**Environmental
Planning
Commission**

*Agenda Number: 02
Project Number: 1000771
Case #: 16EPC-40007
June 9, 2016*

Staff Report

<i>Agent</i>	RBA Architects
<i>Applicant</i>	Brad Allen
<i>Request</i>	Site Development for Building Permit
<i>Legal Description</i>	Tract C Cottonwood Pointe
<i>Location</i>	Between Irving Boulevard and Eagle Ranch Road, south of the Calabacillas arroyo
<i>Size</i>	7 acres
<i>Existing Zoning</i>	SU-1 for I-P, C-2 and R-2 uses
<i>Proposed Zoning</i>	Same

AS-2.0
SHEET NUMBER
02-24-2016
DATE
RBA
ARCHITECTURE
REGISTERED ARCHITECT
NO. 1240
STATE OF NEW MEXICO
REV-1 3/8/2018
REVISION DATE

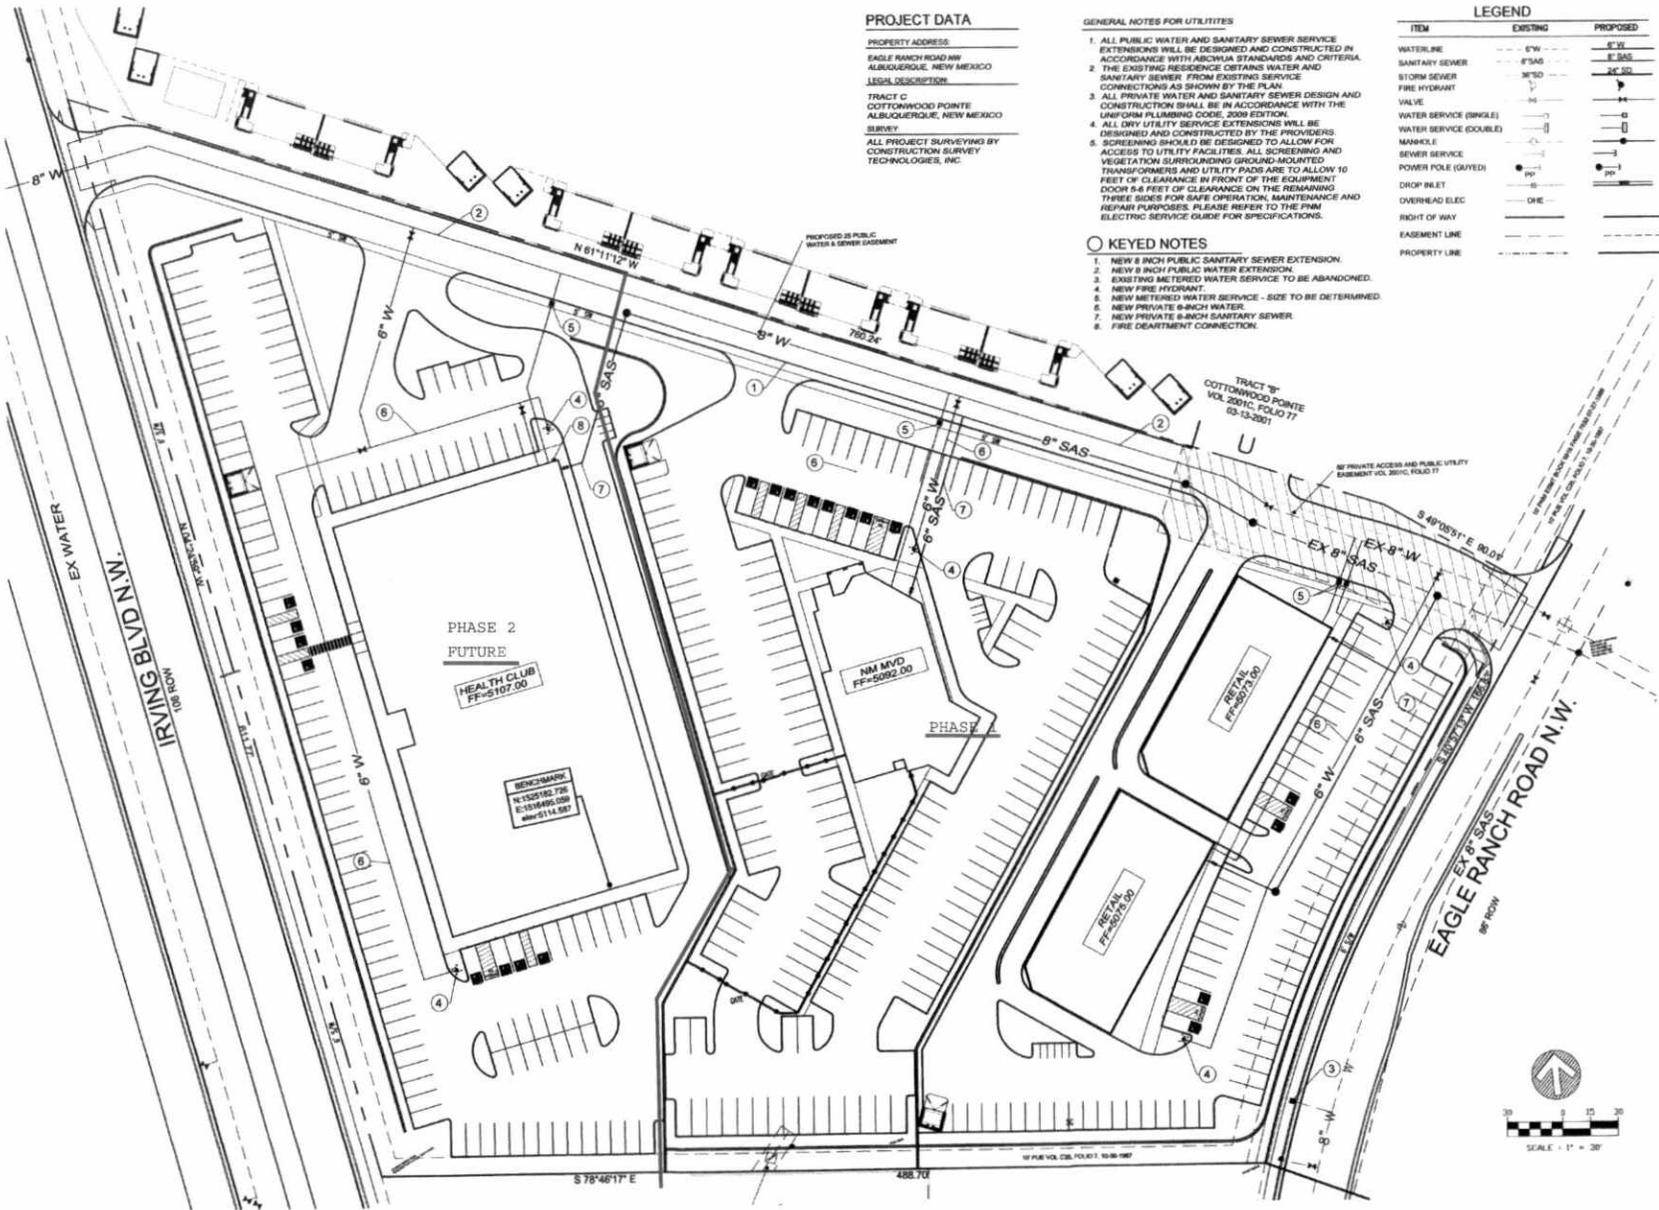
2. Prior to application submittal to the DRB, the applicant shall meet with the staff planner to ensure that all conditions of approval are met.
3. Clarify 141 vs 142 parking spaces shown on sheet AS-1.0.

4. Add a note to sheet AS-1.0 stating that future signage is subject to the requirements of the Coors Corridor Plan and the Site Development Plan for Subdivision
